Access Compliance Report

Public Rights-of-Way

(Curb Ramps)

Intersection ID: 3964	Main Street: GALLOWAY_RD	Cross Street: PARKLEIGH_DR	Location:	N
ADA ID: ADFBFA02B543	Ramp Type: PerpDiag	Initial Pass/Fail: Fail	Overall Compliance: No	Severity Score: 35

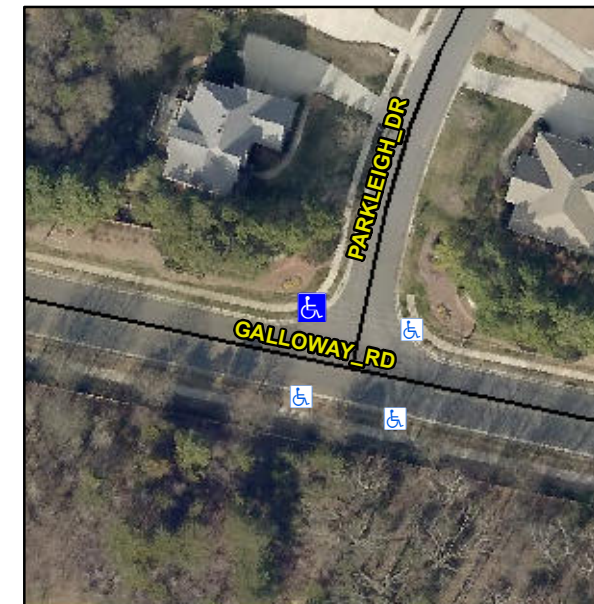
R304.5.1, R304.2.2, R304.5.3

Compliance	Description	Data	Compliance	Description	Data
N/A	Ramp Length (in)	50.0	No	Ramp Slope (%)	20.0
No	Ramp Width (in)	38.0	No	Ramp XSlope (%)	4.7
N/A	Flare Type LT	N/A	N/A	Flare Type RT	N/A
N/A	Flare Slope LT (%)	N/A	N/A	Flare Slope RT (%)	N/A
N/A	Flare Traversable LT?	N/A	N/A	Flare Traversable RT?	N/A
N/A	Landing Length (in)	N/A	N/A	DWS Provided?	N/A
N/A	Landing Width (in)	N/A	N/A	DWS Contrast?	N/A
N/A	Landing Slope (%)	N/A	N/A	DWS Length (in)	N/A
N/A	Landing X Slope (%)	N/A	N/A	DWS Full Width?	N/A
N/A	Landing Curb? (Y/N)	N/A	N/A	DWS Offset (in)	N/A
N/A	Shared Landing?	N/A			
N/A	Gutter Ponding?	N/A	N/A	Gutter Slope (%)	N/A
N/A	Gutter Lip Ht (in)	N/A	N/A	Gutter X Slope (%)	N/A
N/A	Painted X Walk1?	No	N/A	Painted X Walk2?	No
	X Walk 1 Direction	To SW		X Walk 2 Direction	To SE
N/A	X Walk 1 Width (in)	N/A	N/A	X Walk 2 Width (in)	N/A
	X Walk 1 Slope (%)	0.2		X Walk 2 Slope (%)	2.7
	X Walk 1 X Slope (%)	3.1		X Walk 2 X Slope (%)	0.9

Remove & Replace Curb Ramp With Two New Directional Ramps or Equivalent.
